Rezoning Transportation Analysis

Petition Number: 2020-138

General Location Identifier: Tax ID (08705510)

Date	Description
10-23-20	First Review (EL)
11-30-20	Second Review (EL)

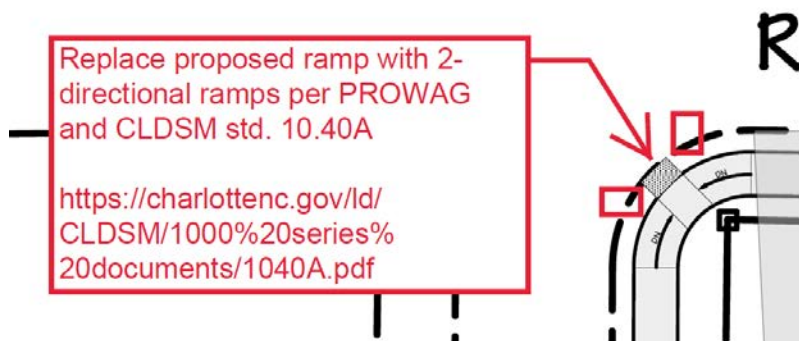
- ~~**Curbline:** The proposed zoning district has a setback measured from back of the existing or proposed future curbline.
 - ~~**Rutgers Avenue:** Location of curb and gutter should be installed at the existing edge of pavement.~~
 - ~~**Ligustrum Street:** Location of curb and gutter should be installed at the existing edge of pavement.~~~~

Label and dimension curb and gutter from the centerline for each road on the site plan.
